RE: Erosion Protection Works at Old Bar
DP524933 – DP1028979 incl Meridian Resort
Your Ref: DOC12/34287

In response to your letters of 7th & 27th August 2012 requesting further information regarding the above application, the specific concerns identified have been addressed below. Also enclosed is a hard copy and electronic copy of the amended drawings [revision A] and consent of owners of 38 & 40 Lewis St. If an amended Statement of Environmental Effects is required, please advise.

Figure 4 – Area of SEPP26 Littoral Rainforest

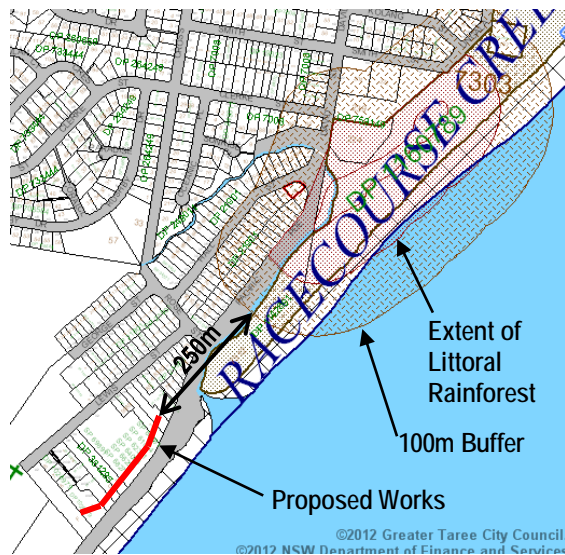
- The potential for impacts on dune vegetation from increased erosion resulting from the seawall and how this is to be managed, especially the *State Environmental Planning Policy No 26 – Littoral Rainforest* area to the north of the site;

The proposed works are located more than 250m south of the 100m buffer zone surrounding the SEPP26 designated littoral rainforest [Figure 4]. As the Worley Parsons [2010] Coastline Management Study indicates a net littoral drift to the south and southerly transport during storm conditions (when the upper beach profile is most likely to be affected), it is expected that the impact of the proposed works would primarily be to the south and the potential for impact on the littoral rainforest some 350m to the north is expected to be fairly limited. It is noted, however, that this area is naturally very vulnerable to erosion and is also affected by the dynamics of Racecourse Creek. This may need to be reassessed in the event of additional erosion making the extension of the wall substantially to the north necessary / desirable.

Figure 5 – Overlay of Pipeline with Proposed Works

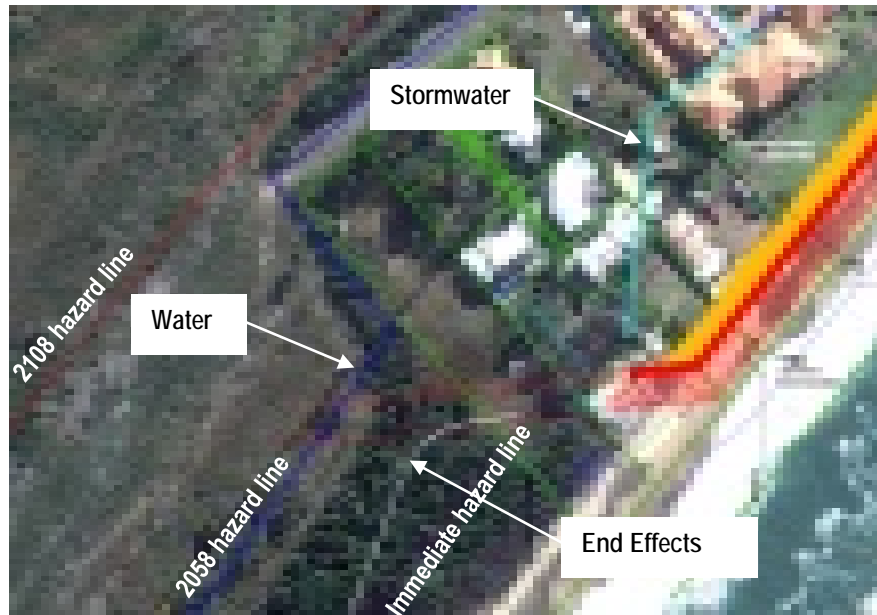
- Any storm water management impacts;

Overlay of these pipeline locations provided by MidCoast Water in their response to the application [Figure 4] indicates that the initial works footprint is clear of existing stormwater, water and sewer pipelines. The worst-case potential for end effects is also initially well clear of the pipelines [Figure 5]. In the medium-term, however, this water pipeline may become affected by erosion which has been exacerbated by the proposed revetment. It is noted, however, that this pipeline is already within the 2058 hazard zone and as such is already vulnerable to erosion. Plans for its eventual protection are unknown, however relocation of this service landward appears to be feasible [Figure 6].
